UNITED STATES PATENT AND TRADEMARK OFFICE

10/533,571

Office Action Summary	Application No. 10/533,571	Applicant(s) MONTAGUTELLI, DENIS	
	Examiner MARISSA L. FERGUSON-SAMRETH	Art Unit 2854

DETAILED ACTION

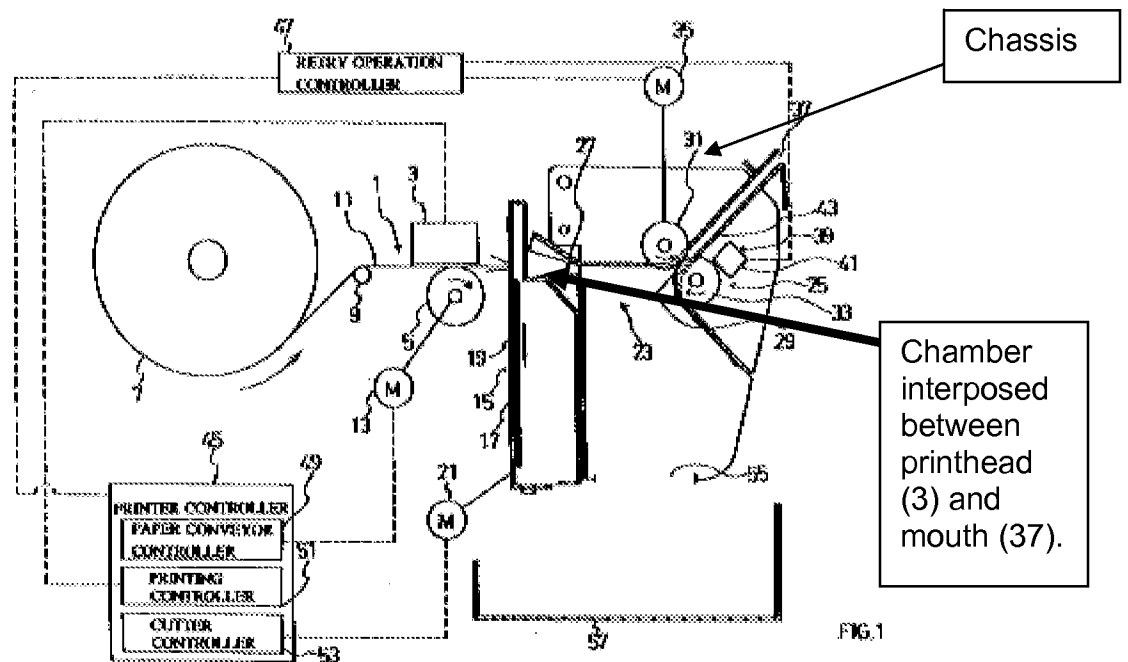
Claims 1 and 2 are rejected under 35 U.S.C. 102(b) as being anticipated by Suzuki (US Patent 6,056,460).

Suzuki teaches a first motorized means (5) for driving a printable band packaged into a roll, from a reserve to a printing head (3; Figure 1), said device being arranged in order to allow user access to the portion of band during printing by circulating through a delivery mouth (37) during the printing process thereof, such a device comprising mainly a chassis (refer to figure in the detailed action) fitted with a mouth (37) for delivering the voucher for the user and connected to the printing mechanism (Figure 1), a chamber (refer to figure in the detailed action) storing a portion of band during printing, which is interposed between the printing mechanism and the delivery mouth (refer to figure in the detailed action), optionally, a cutting member (19) for the separation of the voucher beyond the band, further comprising means for slaving the speeds (45) driving the band during printing, driving the band jointly by the first motorized means (5) and by a second motorized positive driving means (31, 33) for causing simultaneous and regulated implementation of the first and second driving means relative to one another (note: the language is functional language, therefore the driving means indicated has the capability of performing the intended function), the implementation of the slaving means being placed under the control of means for detecting the position of an elastic mobile member for maintaining under tension the band inside the reserve chamber, opposing the driving thereof by the second driving means, a position which varies according to the relative driving speeds of the band, respectively by the first and by the second

driving means (note: the language is functional language and an elastic mobile member is not positively claimed, therefore the slaving means (45) has the capability of maintaining the position of the band due to the speeds of the band).
